May 29, 2018
IDEA PUBLIC SCHOOLS – IDEA Brownsville Robindale Phase I

ADDENDUM NO. 2

A. PURPOSE AND INTENT
This addendum is issued for the purpose of modifying the plans and specifications for the IDEA PUBLIC SCHOOLS – IDEA Brownsville Robindale Phase I

Date: May 11, 2018
Scale: As Noted
Project Architect: David Monreal, AIA
Drawn By: JA, RB
Job No. IDEA Robindale Phase I
Sheet: A2.01

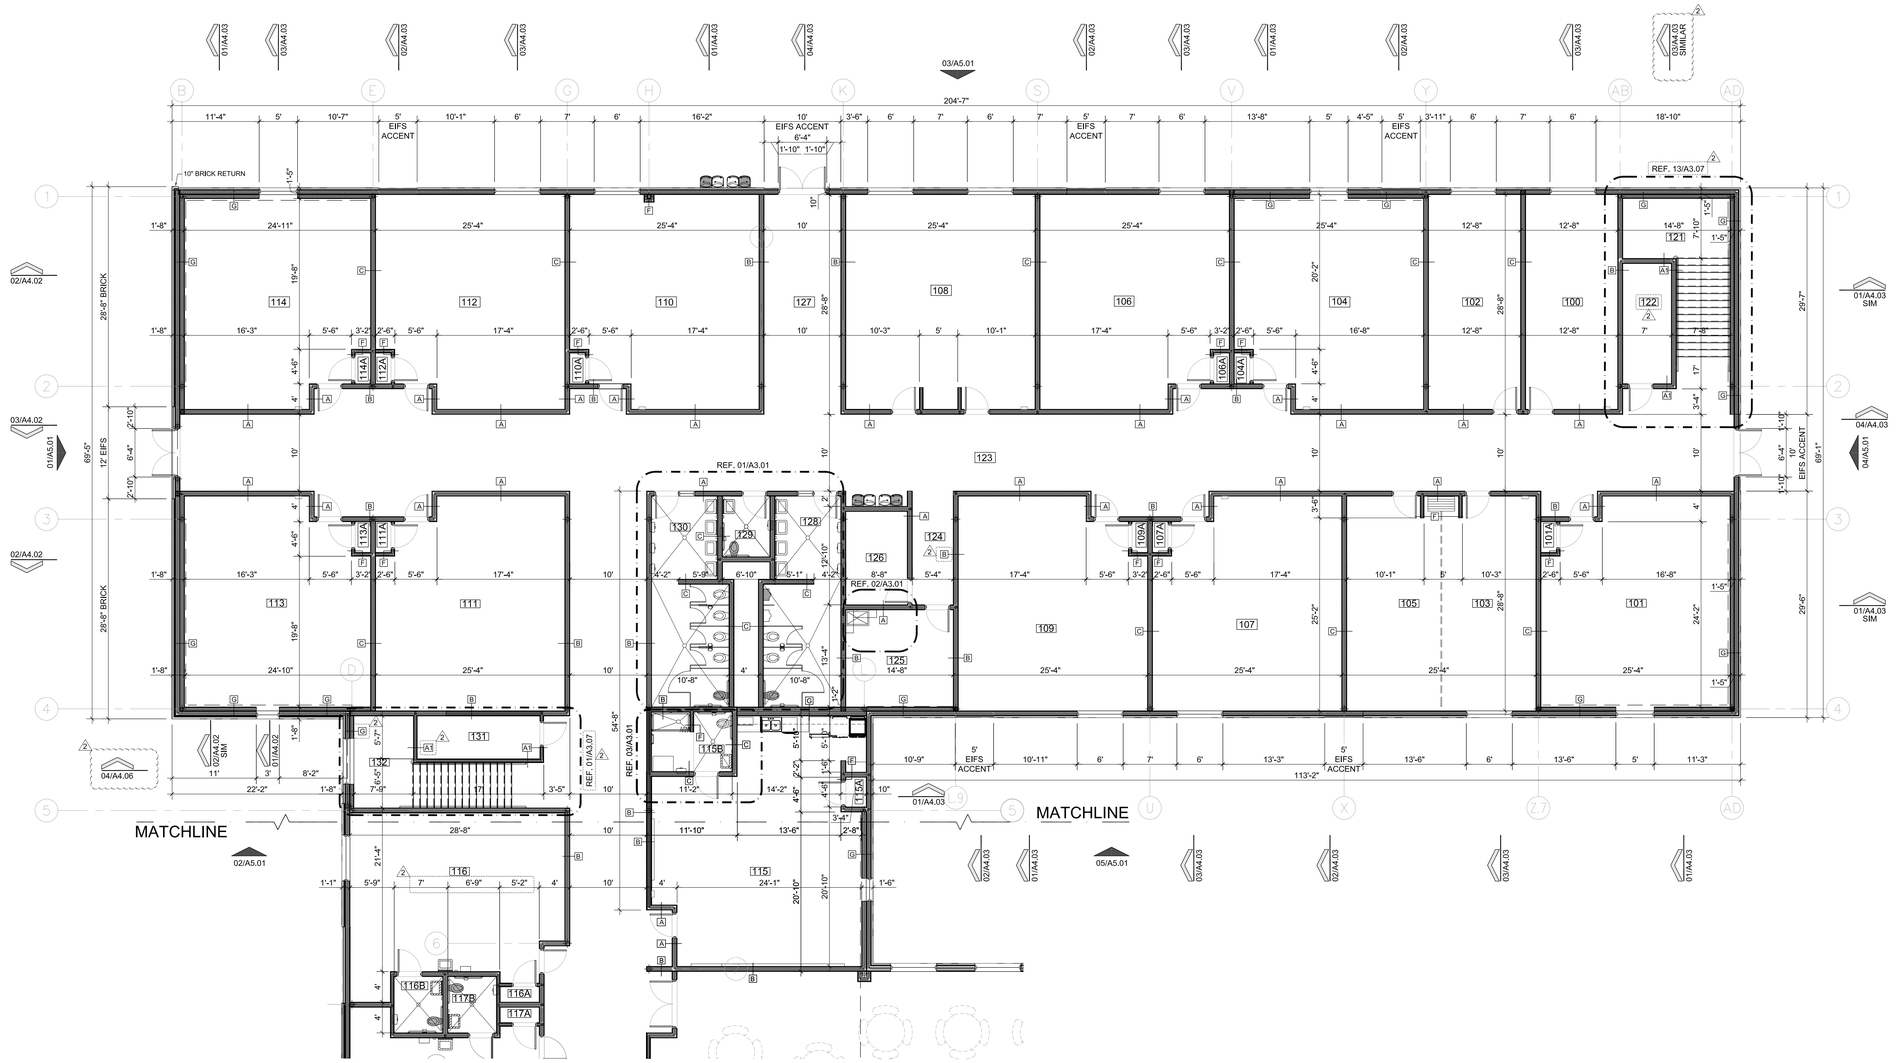
2. Sheet A2.01 – First Floor Plan
    a. REVISE Partition Types, Detail References and Room Finish Schedule – Replace Sheet A2.01 previously issued with Sheet A2.01 included in this addendum.

Date: May 11, 2018
Scale: As Noted
Project Architect: David Monreal, AIA
Drawn By: JA, RB
Job No.: IDEA Robindale Phase I
Sheet: A2.03

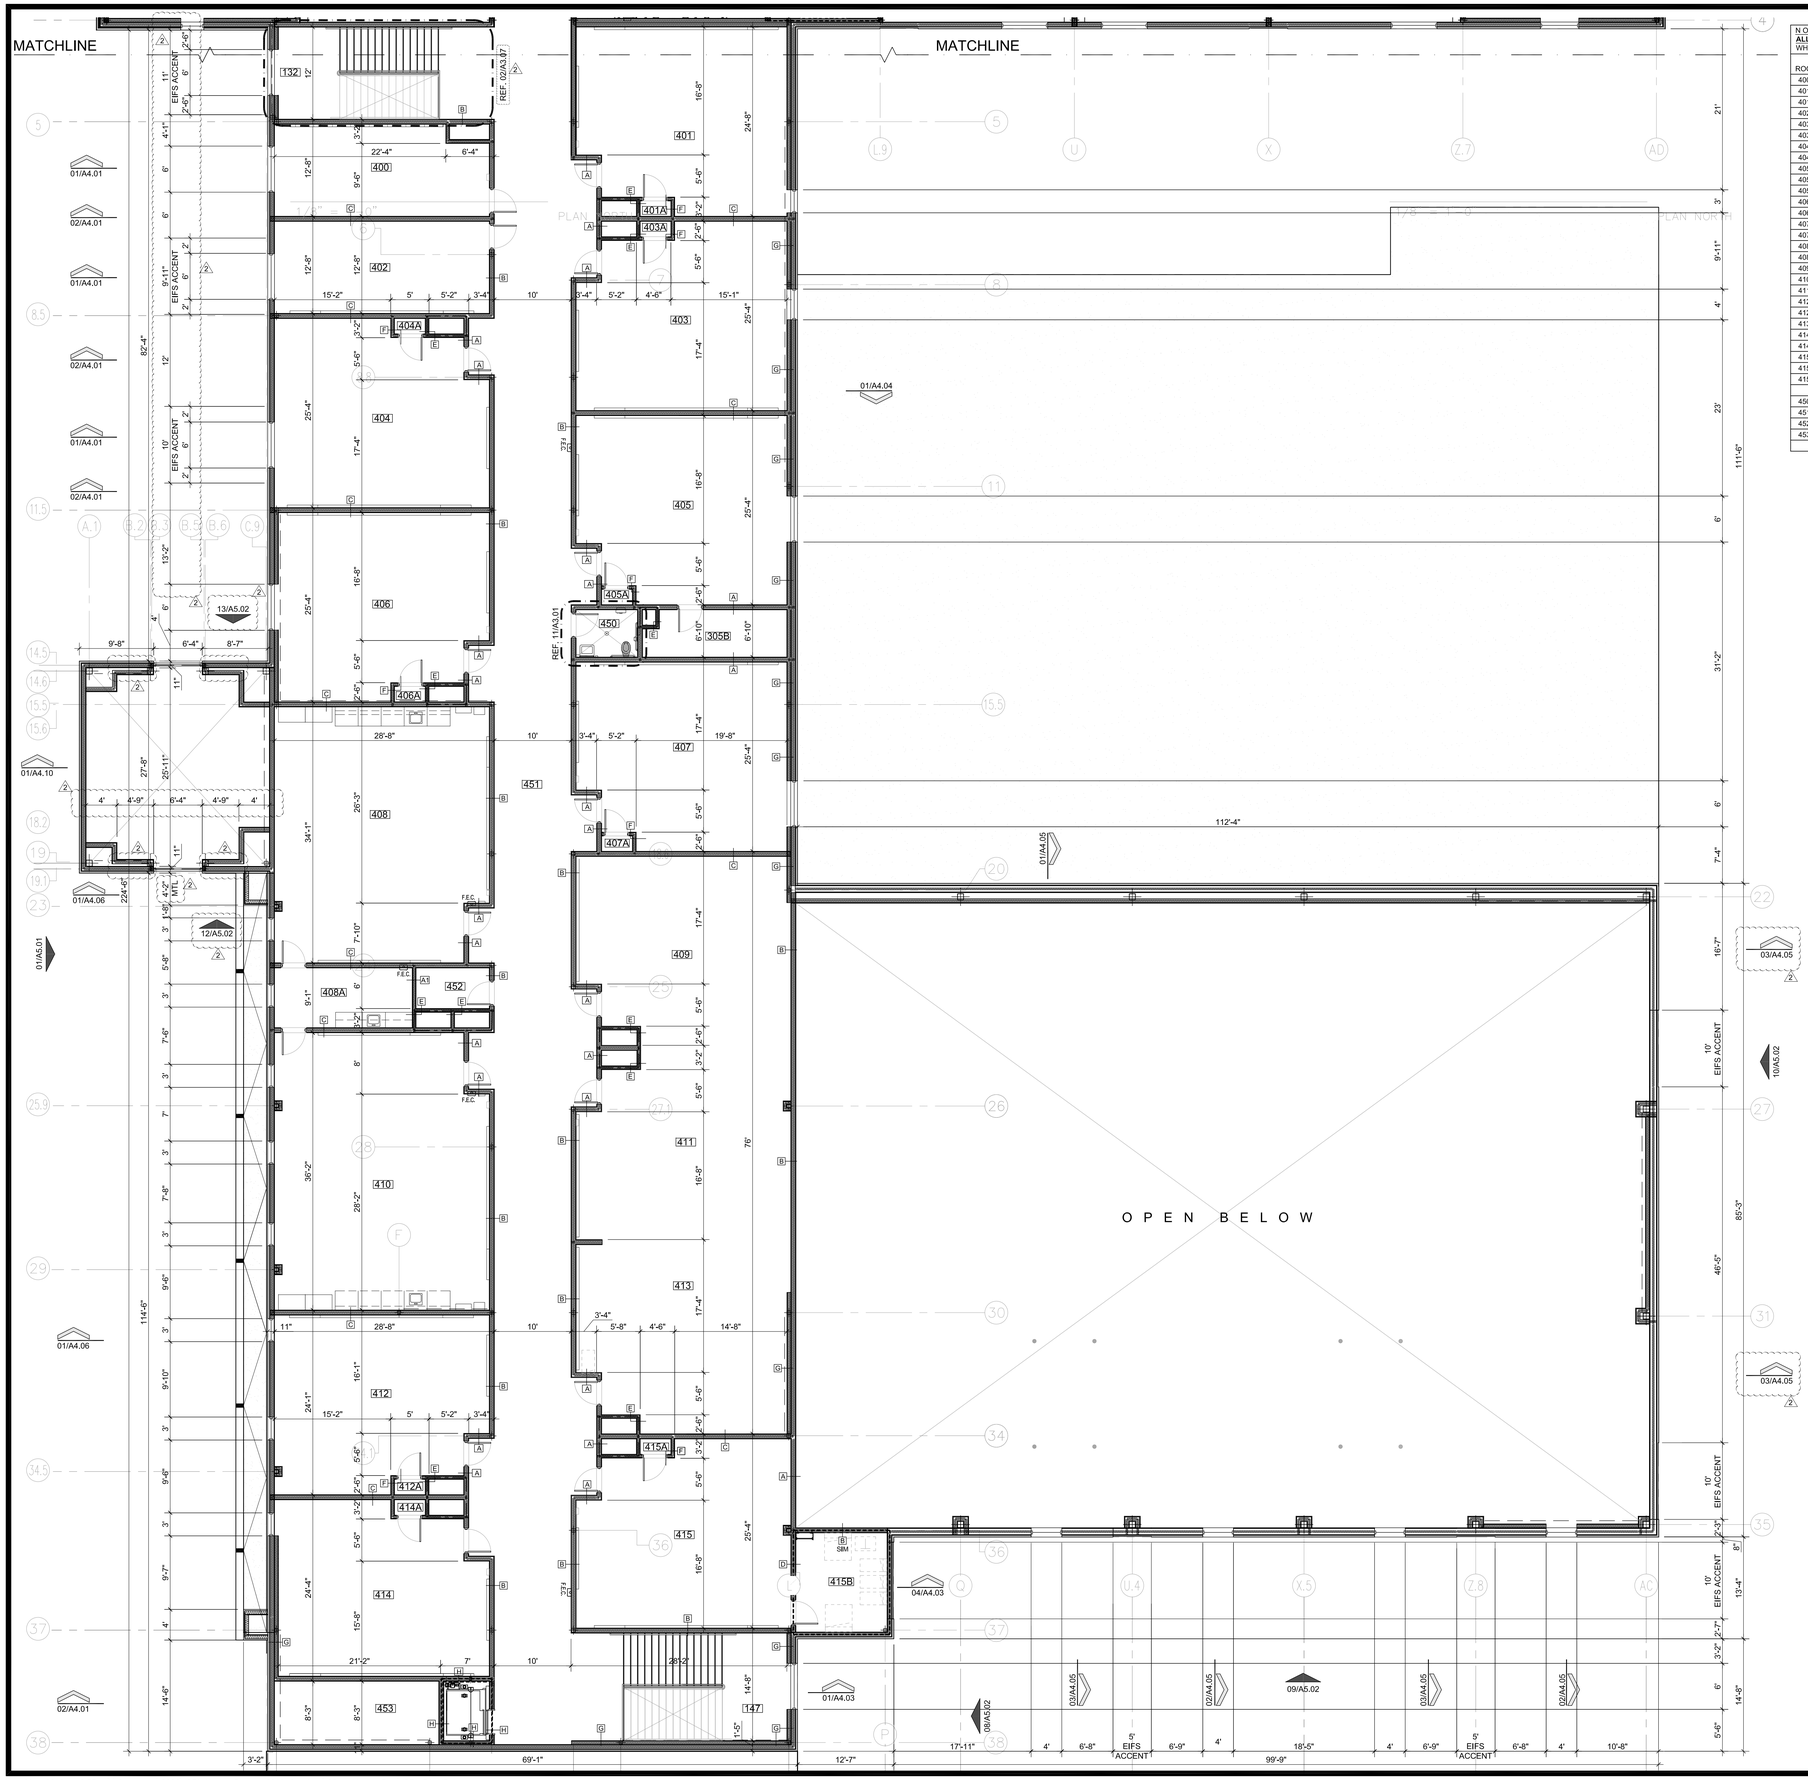
4. Sheet A2.03 – Second Floor Plan
    a. REVISE Partition Types, Elevation Keys, Detail References and Dimension String – Replace Sheet A2.03 previously issued with Sheet A2.03 included in this addendum.

Date: May 11, 2018
Scale: As Noted
Project Architect: David Monreal, AIA
Drawn By: JA, RB
Job No. IDEA Robindale Phase I
Sheet: A2.04

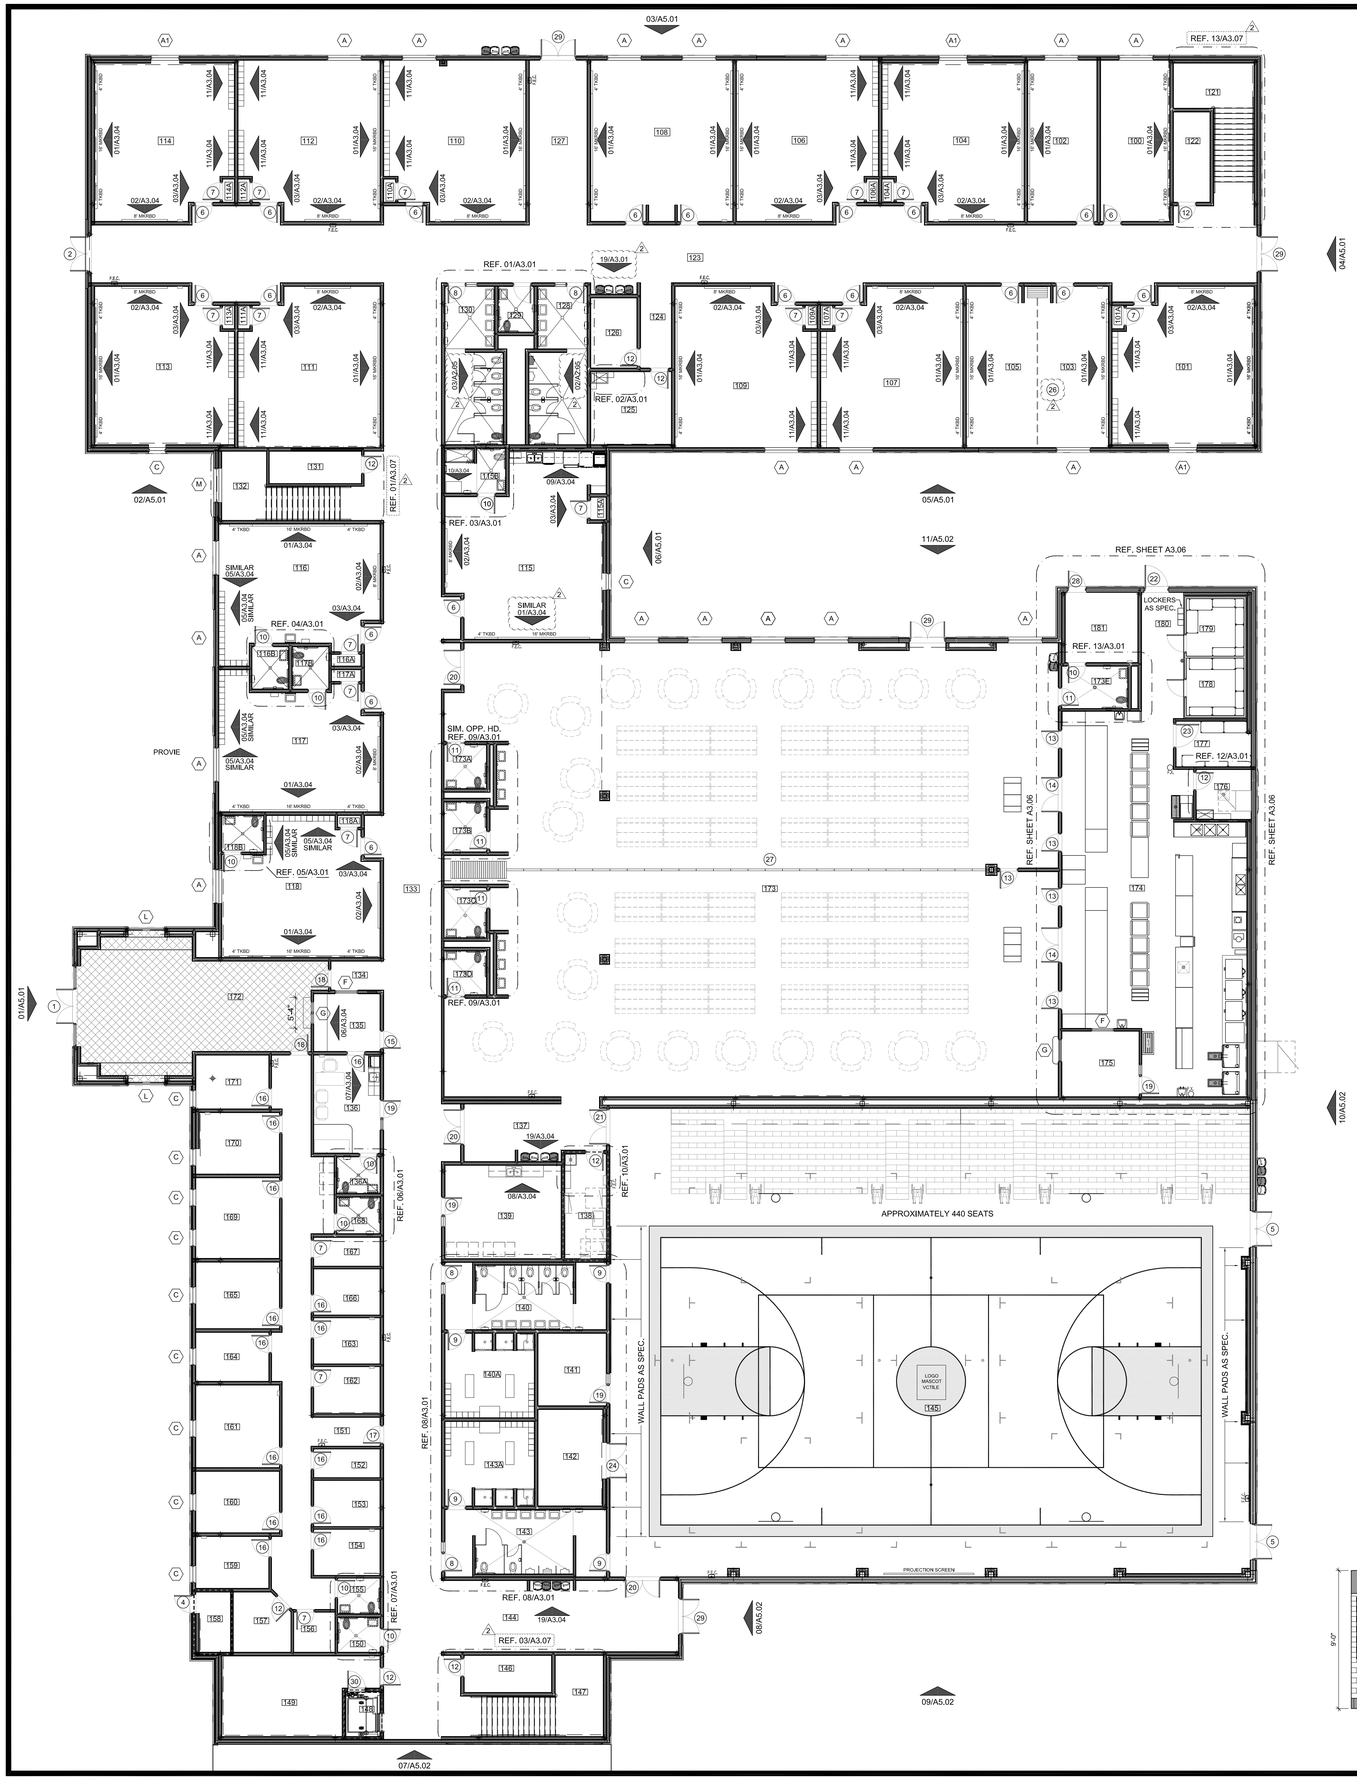
5. Sheet A2.04 – Second Floor Plan
    a. REVISE Elevation Keys, Detail References and Dimension String – Replace Sheet A2.04 previously issued with Sheet A2.04 included in this addendum.

Date:	May 11, 2018
Scale:	As Noted
Project Architect:	David Monreal, AIA
Drawn By:	JA, RB
Job No.	IDEA Robindale Phase I
Sheet:	A2.06

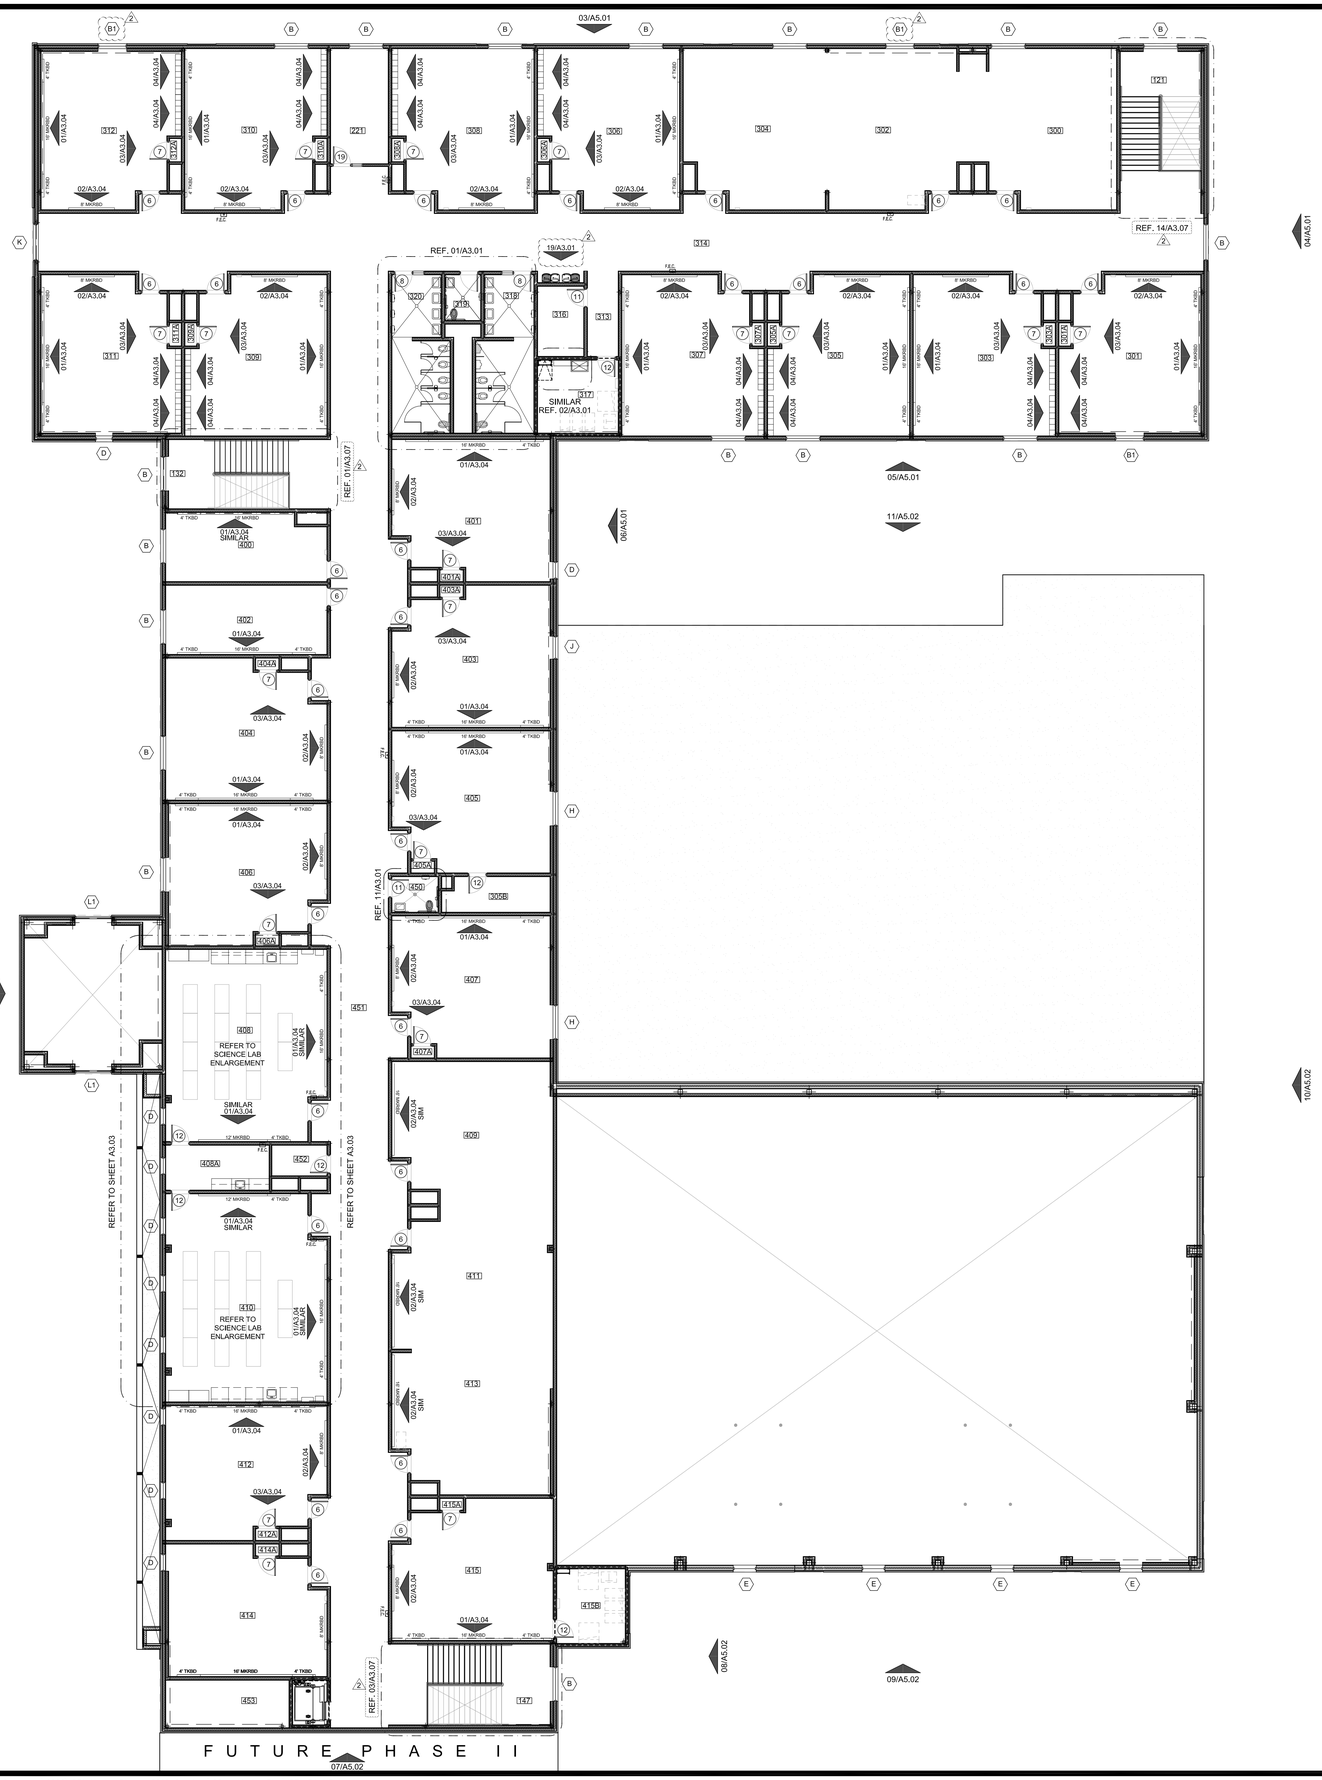
7. Sheet A2.06 – Second Floor Fixture Plan
    a. REVISE Elevation Keys and Detail References – Replace Sheet A2.06 previously issued with Sheet A2.06 included in this addendum.
